CHAPTER 2 TEXT CHANGES TO THE DRAFT EIR

This chapter presents minor corrections, additions, and revisions made to the Draft EIR initiated by the Lead Agency (City of Sacramento), reviewing agencies, the public, and/or consultants based on their review. New text is indicated in underline and text to be deleted is reflected by ~~strikethrough~~, unless otherwise noted in the introduction preceding the text change. Text changes are presented in the section and page order in which they appear in the Draft EIR.

FIGURE 3
Parkside Flats Home Elevations

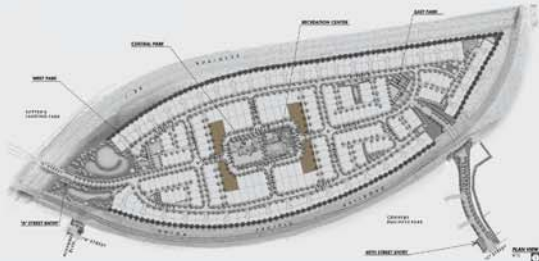
- The number of housing units has increased from 328 to 336. This includes adding a new housing type, Parkside Flats, which includes 24 two-story attached units located around the Central Park.

FIGURE 5
Proposed Onsite Traffic Calming

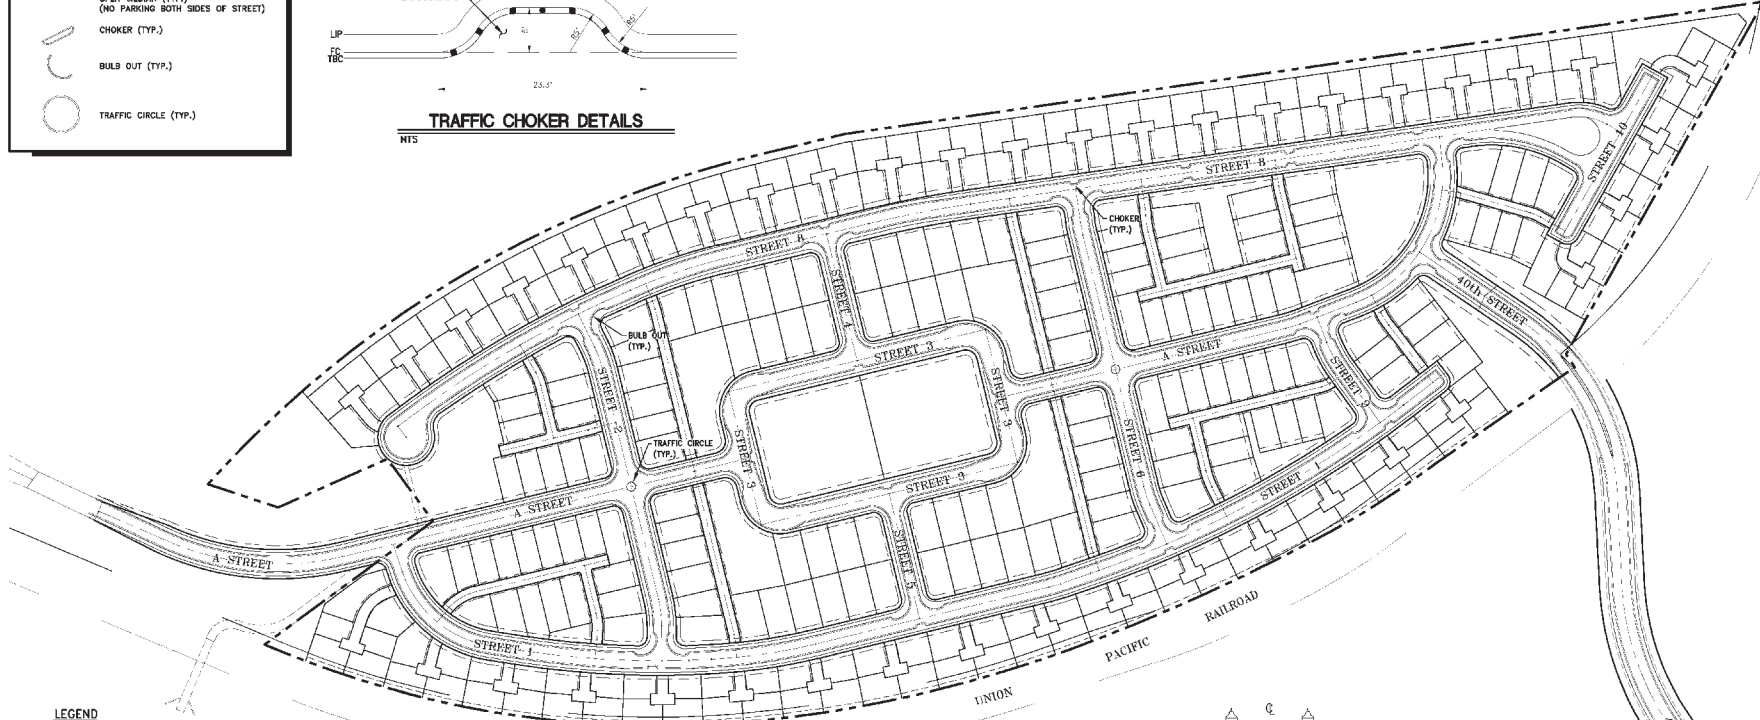
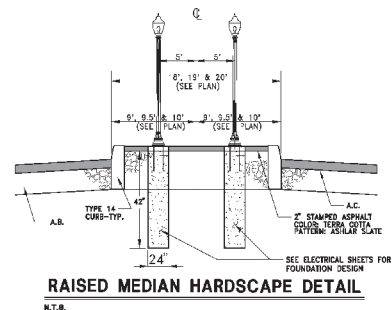
The project also includes a variety of traffic calming measures including bulb outs, chokers, ~~split medians~~, and traffic circles, as described in greater detail in Section 4.9, Transportation and Circulation.

FIGURE 2-20
Site Connectivity

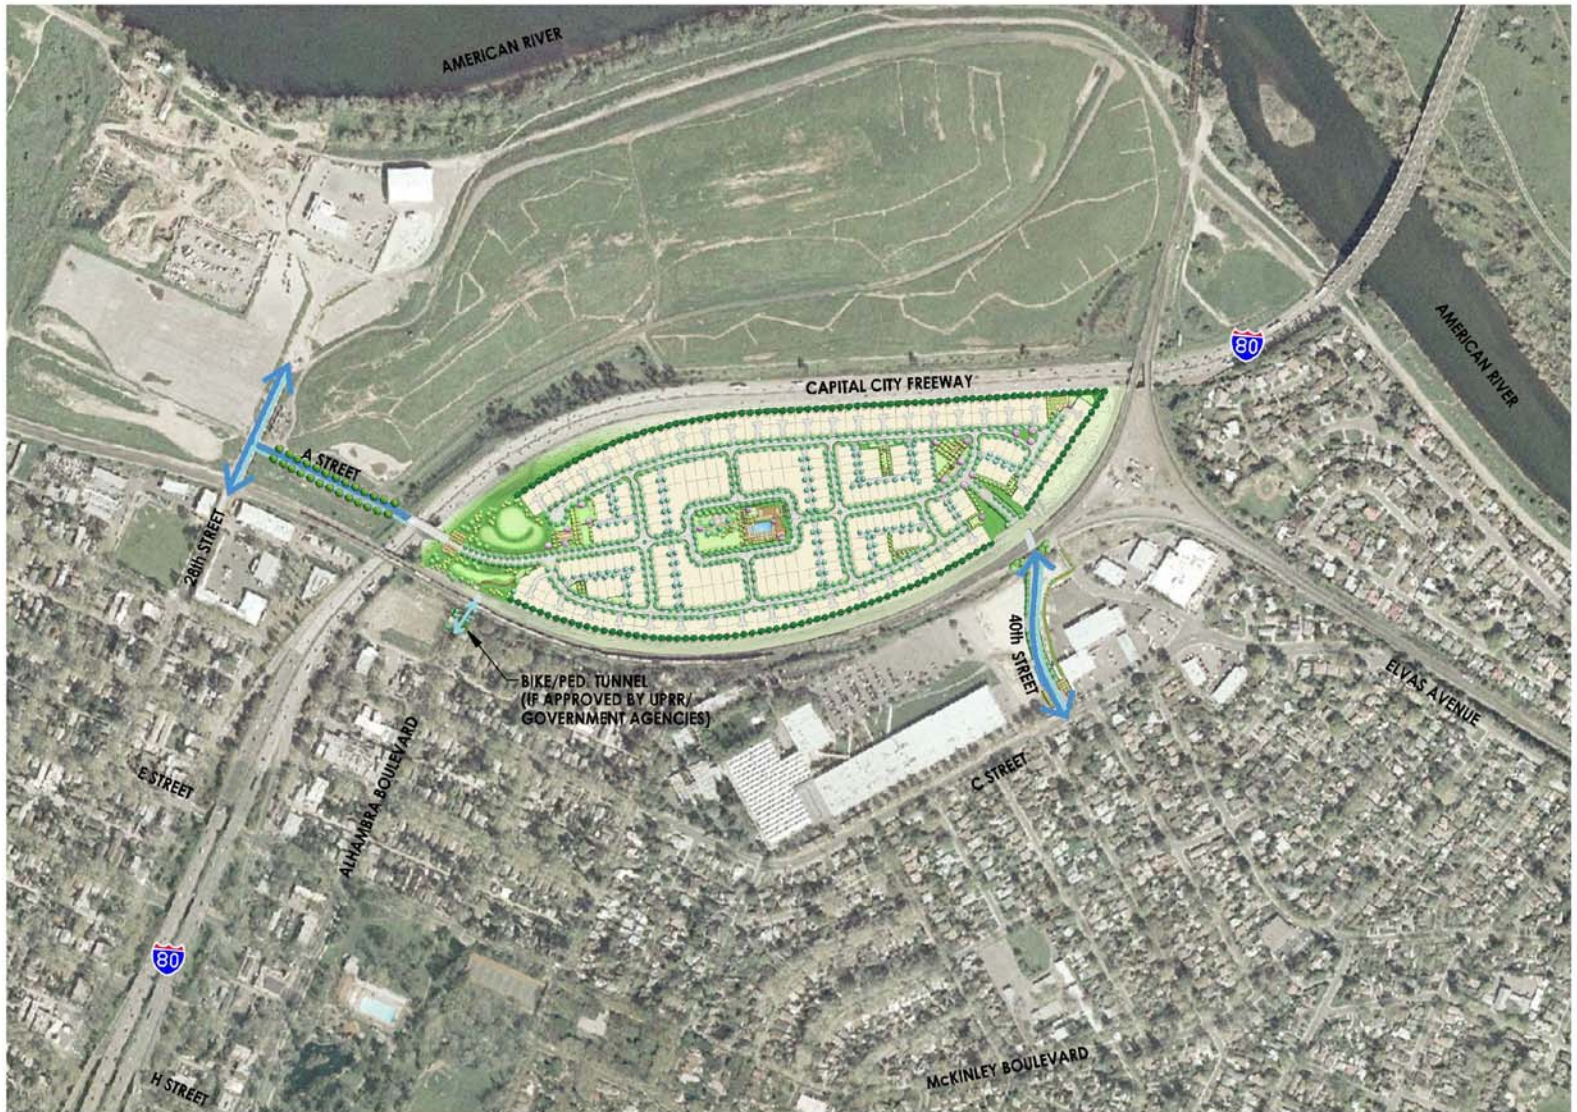
The Alhambra pedestrian and bike underpass would be constructed under the existing UPRR raised embankment at the northerly end of Alhambra Boulevard, if approved by UPRR and the appropriate government agencies. The underpass would provide pedestrian and bicycle access between Alhambra Boulevard and the project site. While public vehicle access would be prohibited, the underpass must provide a minimum width of 12 feet to accommodate City maintenance vehicles for maintenance activities. Removable traffic control devices or an alternative design would prohibit vehicles from traveling through the underpass but would allow access for designated City maintenance vehicles. The length of the underpass is roughly 125.5 feet long and is controlled by the width of the existing railroad embankment and accommodation of future planned railroad

tracks and railroad maintenance roads. LED lighting and cameras at both ends of the underpass have been added to provide a more pedestrian-friendly environment. Lighting would be provided and would adhere to the City's standards for minimum lighting intensity for pedestrians, bicycles, and safety.
